PLANT NAME: Duane Arnold
RJL

May 5, 1977
IE-77-884

PROPOSED CHANGE RTS-80A TO DAEC TECHNICAL SPECIFICATIONS

SAFETY EVALUATION
SAFETY/RELIEF VALVE REPLACEMENT

Figure 3.1a DUANE ARNOLD CO3 VALVE REPLACEMENT STUDY
TURBINE TRIP W/O BYPASS TRIP SCRAM

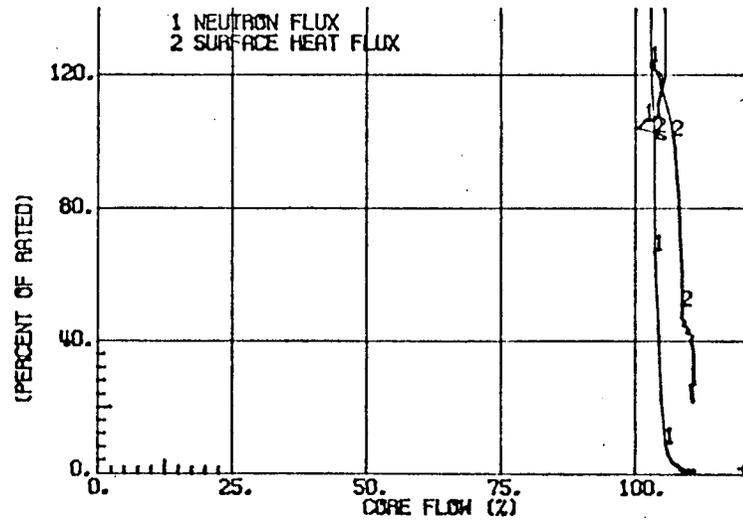
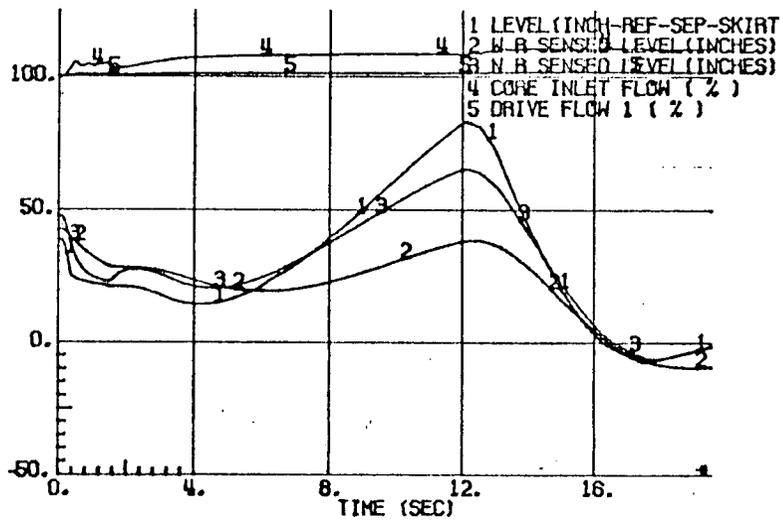
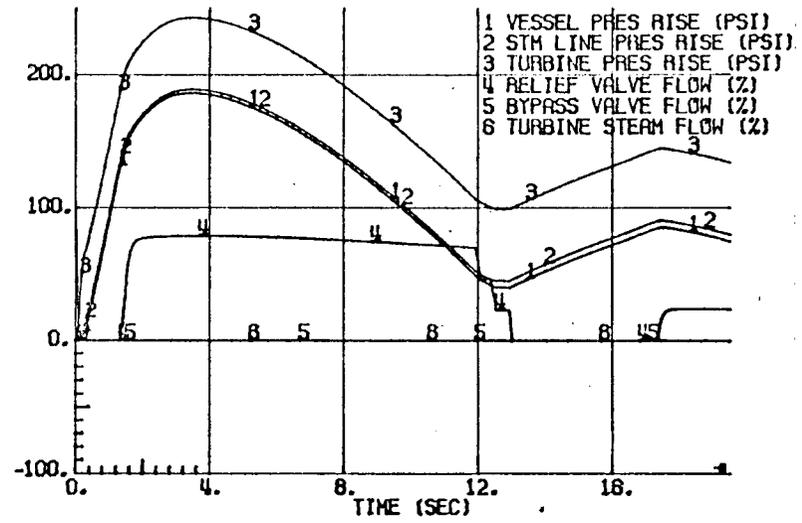
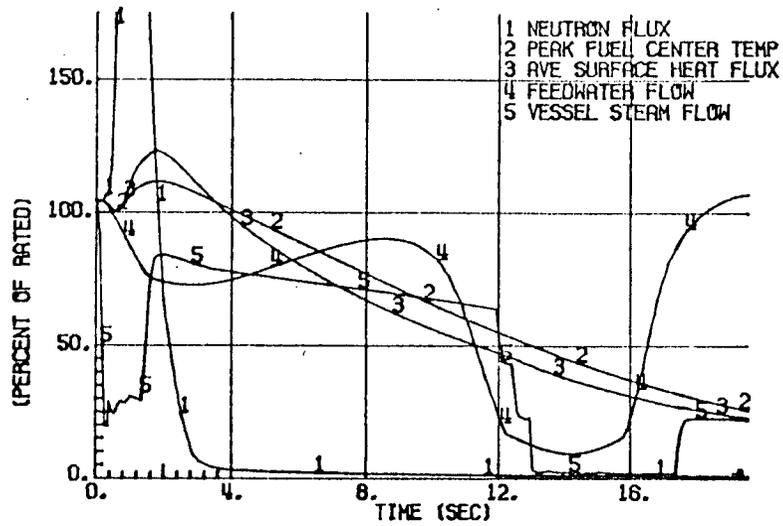
This transient produces the most severe reactor isolation. The primary characteristic of this transient is a pressure increase due to the obstruction of steam flow by the turbine stop valves. The pressure increase causes a significant void reduction which yields a pronounced positive void reactivity effect. The net reactivity is sharply positive and causes a rapid increase in neutron flux until the net reactivity is forced negative by scram initiated from 90% open switches on the turbine stop valves and by void increase after the safety/relief valves have automatically opened on high pressure. Figure 3-1 illustrates this transient.

The peak streamline pressure is limited to 1204 psig as a result of the high-pressure actuation of the six safety/relief valves which provides a 36 psi margin to the 1240-psig set point of the first spring safety valve.

Change the "80 psi" on sheet 3.6-24 of proposed Technical Specification Change RTS-80 previously submitted to the NRC (Letter IE-77-220, Mr. D. Arnold, President, Iowa Electric Light and Power Company to Mr. B.C. Rusche, Director, Office of Nuclear Reactor Regulation, Dated January 31, 1977) to "79 psi". On the same sheet change "40 psi" to "36 psi".

Figure 3-2

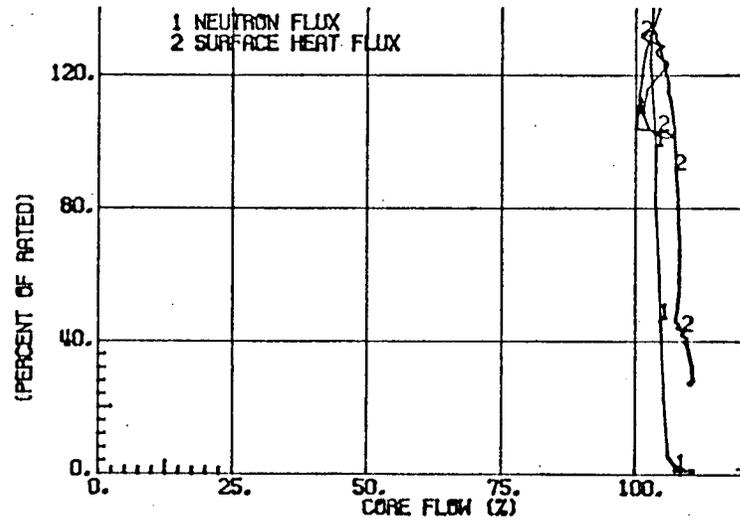
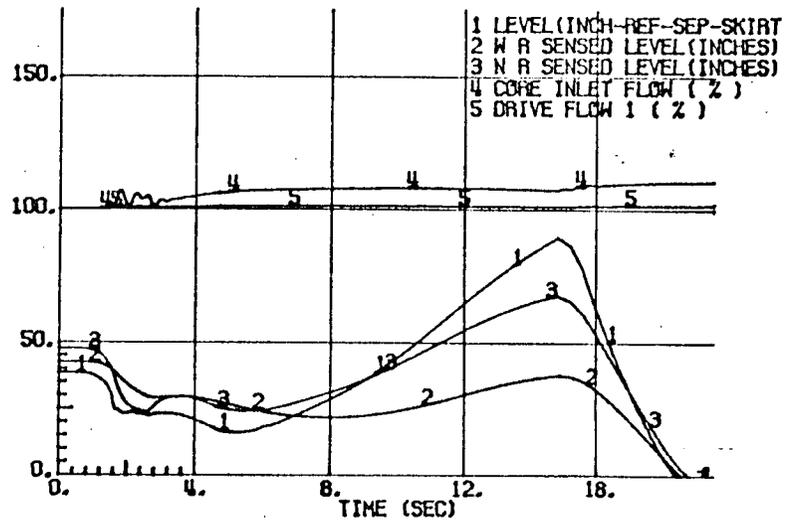
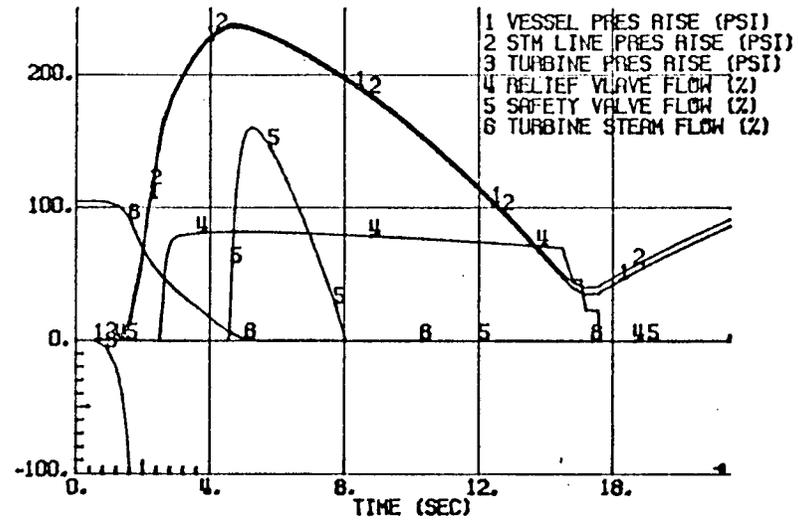
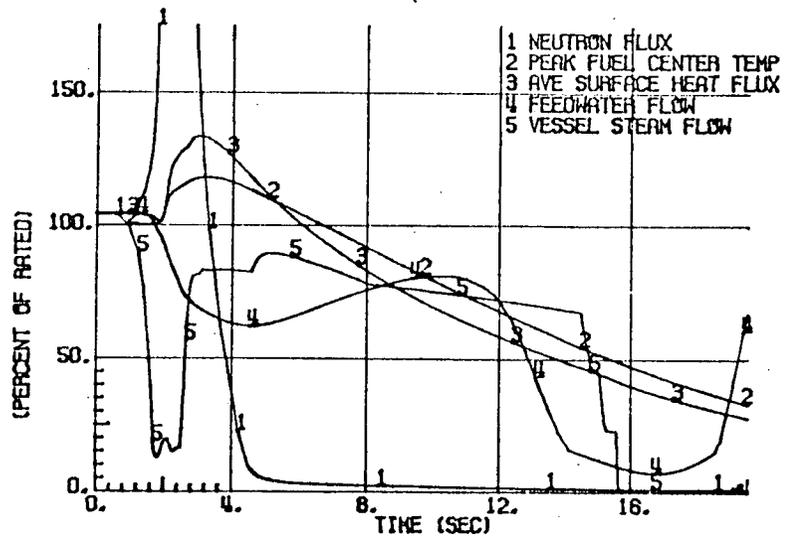
The event which satisfies this specification is the closure of all main steamline isolation valves with indirect (flux) scram. The initial conditions assumed are those specified in Table 3-1. Figure 3-2 graphically illustrates the event for exposure at EOC3. The response indicates a ≥ 79 psi margin to the vessel code limit of 1375 for EOC3. Thus, requirement a. is satisfied and adequate overpressure protection is provided by the pressure relief system.
